**Date:** February 11, 2020  
**To:** Planning Board  
**From:** Kellie Shamel, Town Planner  
**Subject:** Frederick & Celia Lorden Trust (owner) and Ponemah Hills, LLC (applicant) – Review for acceptance and consideration of final approval for a major site plan to construct a 6,447 square foot, 9-unit multifamily residential building with a nine stall carport along with associated site improvements. The parcel is located at 0 Ponemah Hill Road in the Residence B District. Tax Map 43, Lot 61.

**Re: Ponemah Pines Site Plan, Ponemah Hill Road (Map 43, Lot 61)  
Drainage Review**

SITE DEVELOPMENT PLANS  
**PONEMAH PINES**

**LIGHTING & LANDSCAPING PLAN**  
**PONEMAH PINES**  
TAX MAP 43 PARCEL 61 - PONEMAH HILL ROAD  
MILFORD, NEW HAMPSHIRE

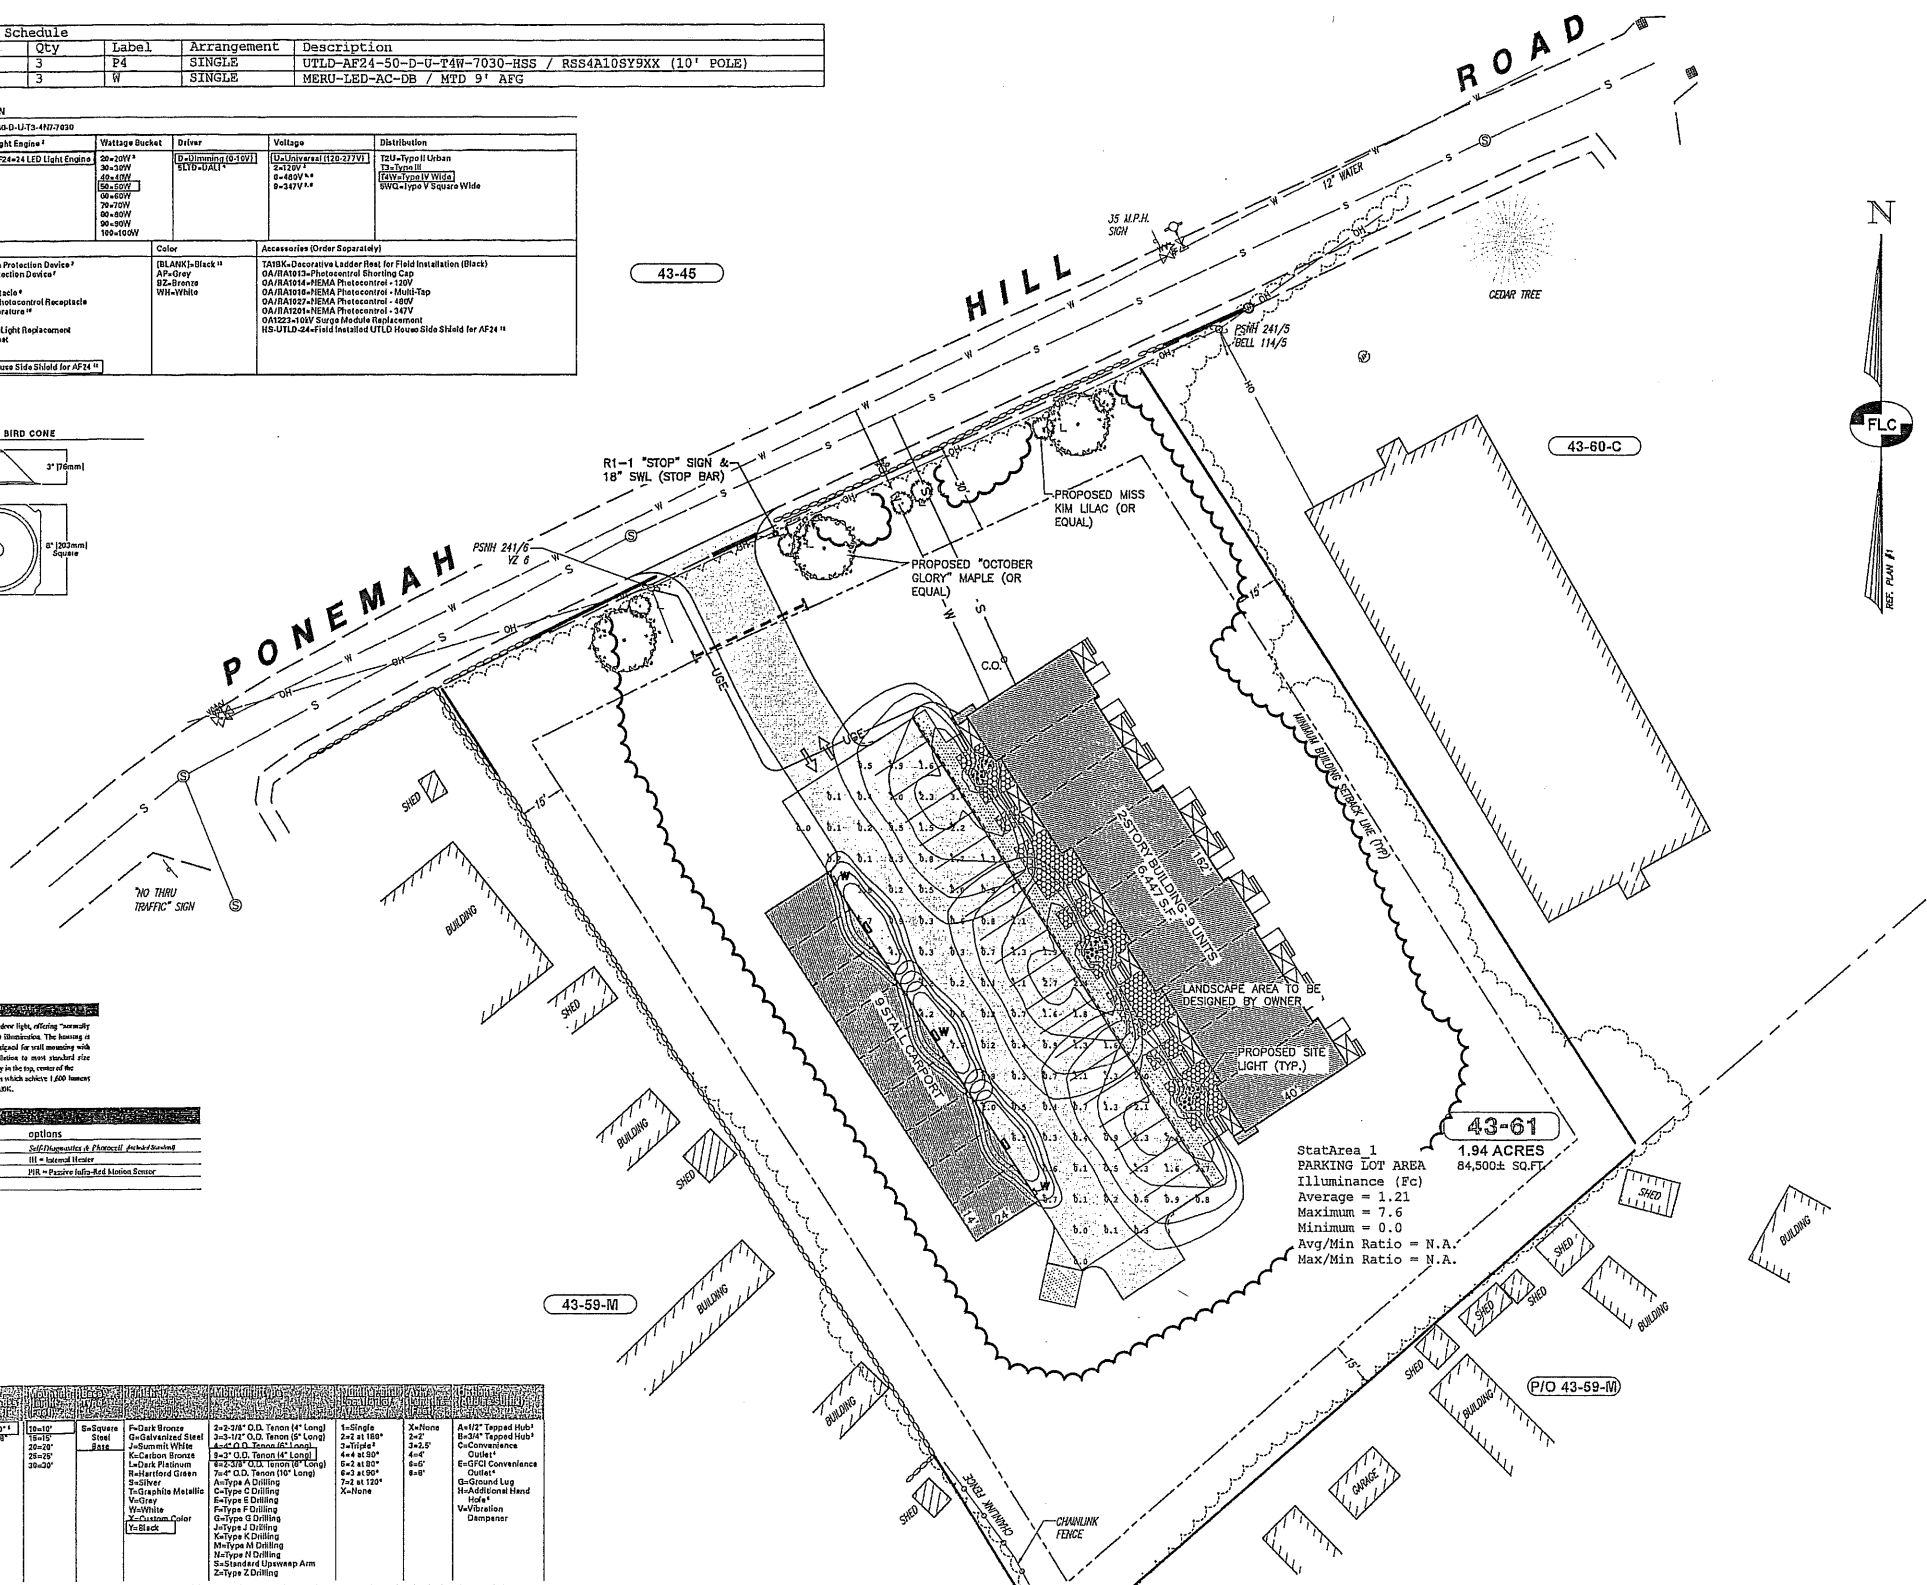
4. Landscape Plan. Staff would recommend additional tree plantings along the frontage of Ponemah Hill Road in compliance with Section 6.08.7.A.2 requiring one tree per each 30 feet of landscaped strip along the access way (unless it can be shown that existing trees meet these requirements).

5. Landscape Plan. Staff would recommend additional landscaping within the site in compliance with Section 6.08.6 requiring a minimum of 1 shrub for every 5 feet of building frontage and additional landscaping within the site that is compliant with Section 6.08.7.

**INFILTRATION BASIN SECTION** DT-1

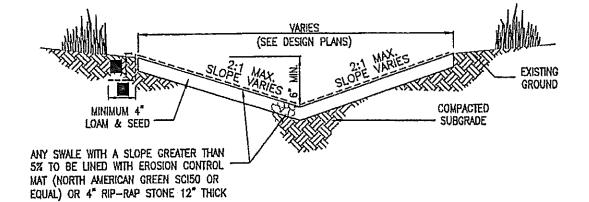
1. The stormwater mitigation relies completely on infiltration at a single basin at the northeast corner of the lot. Considering the basin is located very close to the abutting property line and roadway right-of-way line and all the stormwater from the site is being directed to a single location, there is a concern that the large concentration of stormwater may overflow the stormwater basin (if infiltration efficiencies decrease over time) onto abutting properties and the roadway swales which will be problematic. It is strongly recommended that the infiltration mitigation be spread around the site (there are clear opportunities for this) to prevent a concentration of flow at one point.

PAVEMENT TRENCH PATCH SCALE: N.T.S. DT-2

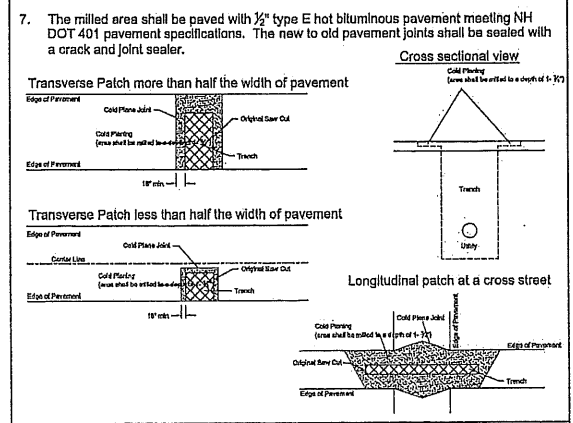
The trench patch detail is not per town of Milford, trenches are base paved flush full thickness, then milled 1 ½" , to a minimum distance of 2' each side of trench.
